REDLAND WOODS

MASTER DEVELOPMENT PLAN

353

RE: Redland Woods Subdivision POADP #353

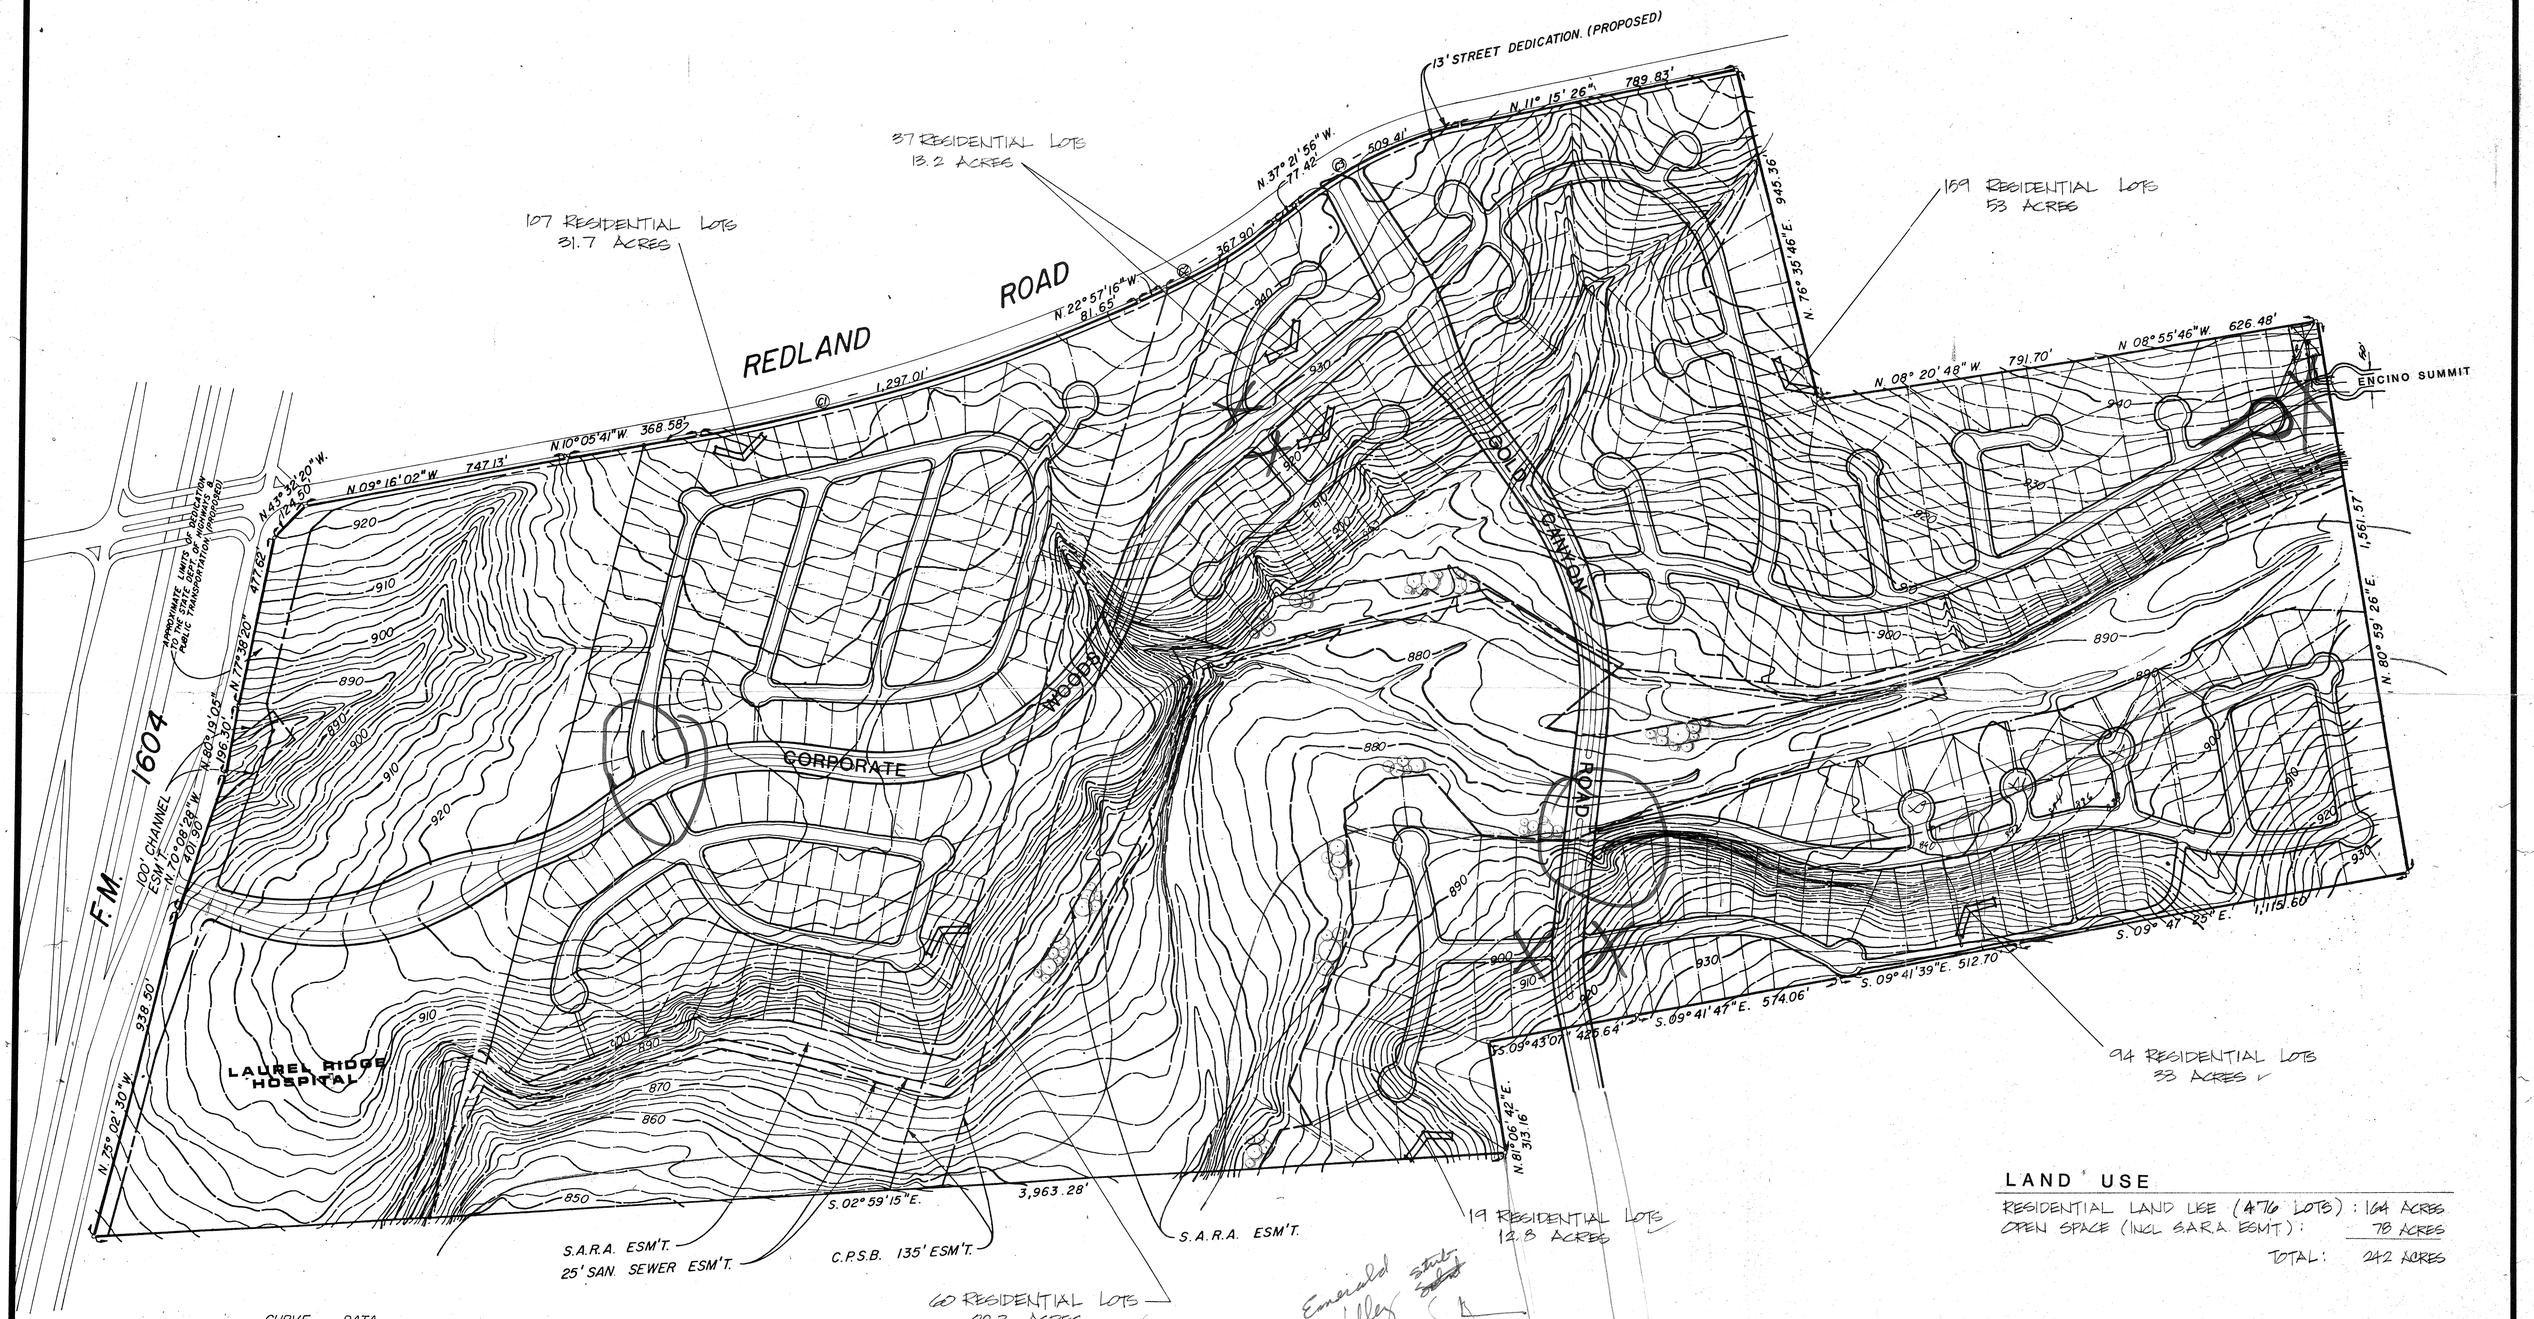
As per your most recent telephonic conversation with my staff, it is my understanding that you have agreed to cul-de-sac the proposed connection with Encino Summit. A cul-de-sac is preferred by city staff as previously delineated in our March 8, 1993 letter.

Additionally, the Traffic Design Engineer has suggested that the two additional longer streets north of Gold Canyon Drive be flared at their intersection with Gold Canyon as was done with the extension of Corporate Woods. The Traffic Design Engineer also prefers that both sides of the intersection with Corporate Woods on the southern half of the proposed development be flared. Flaring at all of these intersections will facilitate better traffic movements and smoother flow.

1. Local streets within your clusters of proposed residential development may not tie into arterial streets. Therefore, collectors need to be provided.

2. Your proposed connection to Encino Summit is not appropriate. Encino Summit was not designed as an arterial street.

The proposed Redland Woods Subdivision layout would cause this previously existing Local, Type A, street to have a direct connection to a Secondary Arterial, Type A, street, Gold Canyon Road. This is, of course, contrary to Policy #1.10 of the Major Thoroughfare Plan, which is stated as follows

In addition to the policy perspective, the specific effect of connecting Encino Summit to Gold Canyon will be to provide a shortcut between the large residential subdivision of Encino Park and Loop 1604 East. The results will be adverse to all residents of Encino Summit as well as other Encino Park streets with residential frontage, e.g., Encino Crown, Encino Cliff, etc.

Because these existing streets have residential frontage and serve as Local, Type A, streets, I recommend against pressing them into service as defacto collectors by connecting Encino Summit to Gold Canyon Road.

In response to the March 19, 1993 POADP Review regarding the Redland Woods subdivision, staff is in agreement with Mr. Ballard's recommendation against connecting Encino Summit to Gold Canyon Road.

In summary, the Transportation Division recommends against connecting Encino Summit to Gold Canyon Road not only from a policy perspective, but from a welfare perspective as well.

3-16-93	REVISED UNIT 1 - STREET & LOT LAYOUT DUE TO TREES	JCH

Enclosed is a revised Master Plan for our 242 acre tract of land off Redland Road. The revision to the plan create a cul-de-sac in our unit 1, which eliminate a direct connection with Encino Summit Dr, as per your recommendations in your letter dated March 25, 1993.
